**Report: ISSUES
Function: Test, Adjust, & Balance
Date: 04/24/2023**

**PROJECT
04-24-23 CULVERS - CAMDENTON, MO**

Issue Name : Diffuser 2-15 is not installed

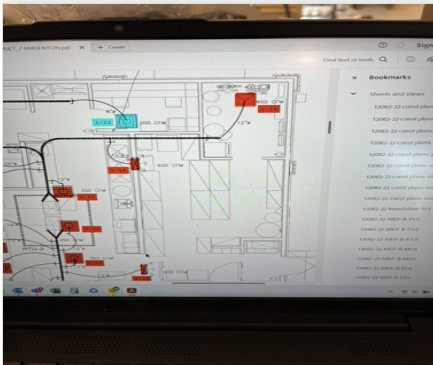
Description : Diffuser 2-15 for the electrical room is not installed. GC said diffuser should be on site and should be installed, but they just got the ceiling up back there so they were waiting until then. Tech cannot balance RTU2 until this is resolved.

Issue Name : EF1A not installed

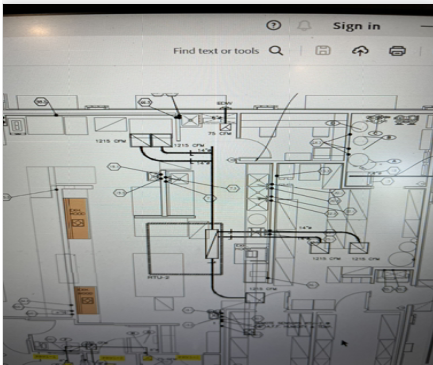
Description : 75CFM Exhaust fan above the mop sink is not installed. I asked the GC and he said they had an extra fan in the end so he's going to see what can be done.

Issue Name : PRV1 missing backdraft damper

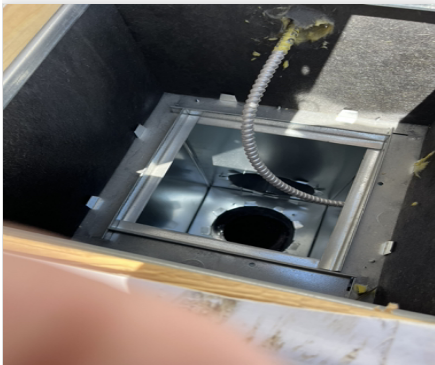
Description : INFO ONLY Restroom exhaust fan is missing the backdraft damper at the curb on the roof. This needs to be installed but will not affect the scope of the TAB.
